To: anthony.brown@bp.com[anthony.brown@bp.com]
Cc: gr@burlesonconsulting.com[gr@burlesonconsulting.com]; Mike Johnson[mike.johnson@copperenv.com]; Doug Carey[douglas.carey@waterboards.ca.gov]; Cory Koger[Cory.S.Koger@usace.army.mil]; lily tavassoli (tavassoli.lily@epa.gov)[tavassoli.lily@epa.gov]
From: Deschambault, Lynda
Sent: Wed 4/12/2017 5:16:46 PM
Subject: RE: Leviathan Mine Aspen Seep Bioreactor update

From: Deschambault, Lynda [mailto:Deschambault.Lynda@epa.gov]
Sent: Thursday, April 6, 2017 4:03 PM
To: Brown, Anthony R (RM)
Cc: Mike Johnson; Greg Reller; Cohen, Adam; Wirtschafter, Joshua; Helmlinger, Andrew; Cory Koger; Chang, Kay SPK; tavassoli, lily; Doug Carey; Black, Ned; Serda, Sophia; Yogi, David
Subject: FW: Leviathan Mine Aspen Seep Bioreactor update

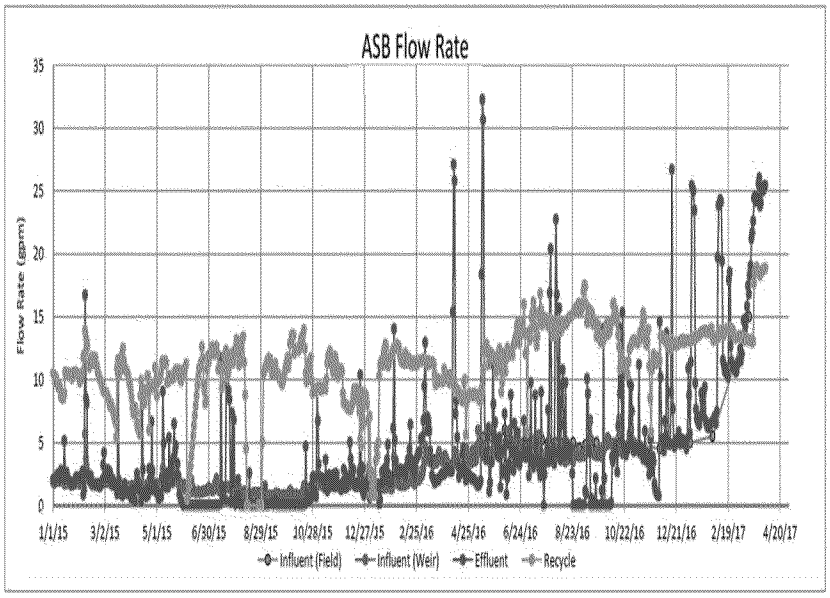
1) **Flow Rates**: Could you please provide some additional updates on charts and figures regarding flow, freeboard etc? For instance this one:

Please see the chart below which illustrates the recent influent flow rate (field measurements) and effluent flow rate data from the Aspen Seep Bioreactor (ASB) Treatment System. We have not received the downloaded influent flow rate data since 12/31/16; however, our approximately monthly field measurements are shown on the chart. In addition, the influent flow rate was manually measured at approximately 25 gpm during the 4/6/17 field visit. As we have had to temporarily remove the 1" effluent flow meter, we will not have effluent flow rate data until it (or a larger 2" flowmeter) can be re-installed. During the 4/6/17 visit, the debris at the launder was removed, and the Pond 4 water elevation was lowered through the use of a siphon. The 1" section of discharge piping and the 1" flowmeter was replaced with 2" flexible piping. The new 2" piping was flowing at approximately 100 gpm while the Pond 4 elevation was lowering (see attached photo). At the time that the maintenance crew left the site, the effluent flow rate had still not yet reached equilibrium.

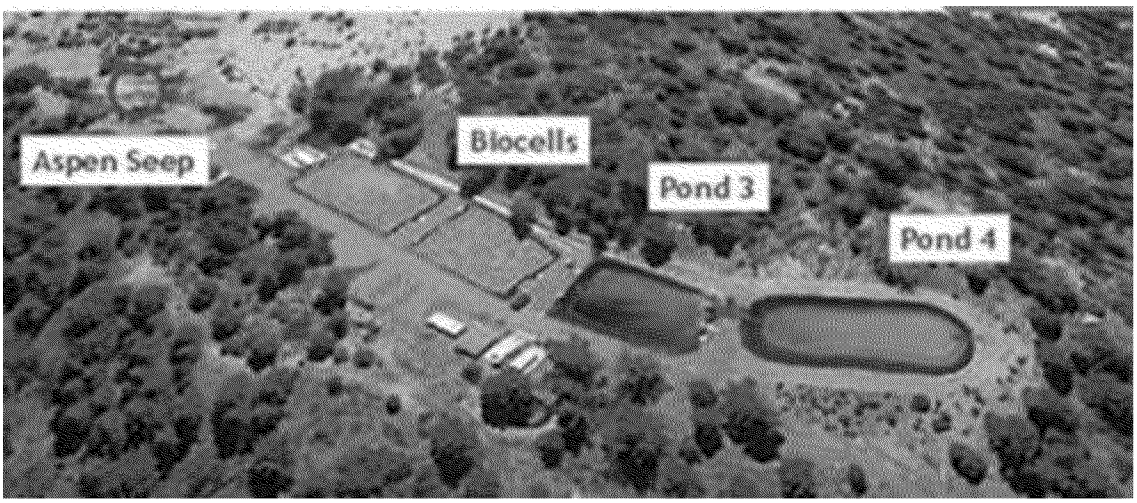
5) **Erosion:** Please let us know if there is an engineered way of controlling excessive fluid flowing into and out of Pond 4 . If there is the potential for fluid flowing directly over the Pond 4 berm, there would likely be erosion between Pond 4 and the I/O pond. If

erosion in that area continued unabated, it is reasonable to assume that some head cutting would occur in the direction of Pond 4 itself. Please assess the severity of head cutting, and whether or not the structural integrity of the ASB Pond 4 could be threatened.

In addition, here are some before and after photos from the 4/6/17 site visit. As you can see, we gained approximately 2 “stairs” of freeboard which provides approximately 100,000 gallons of storage in Pond 4. As a result of the maintenance activities on 4/6/17, we believe there is adequate capacity to get through the forecasted storm this weekend.

The modification of the Pond 4 discharge that was completed on 4/6/17 increased the effluent flow from 25 gpm to over 100 gpm. Once the pond level drops, this flow will reduce to match the influent flow plus precipitation and runon. The modification increased the flow enough that we do not anticipate the potential for a pond overflow. Again, as we gain regular access to the Aspen Seep Bioreactor we would be able to reinstall the effluent flow meter and gain more remote monitoring capabilities.
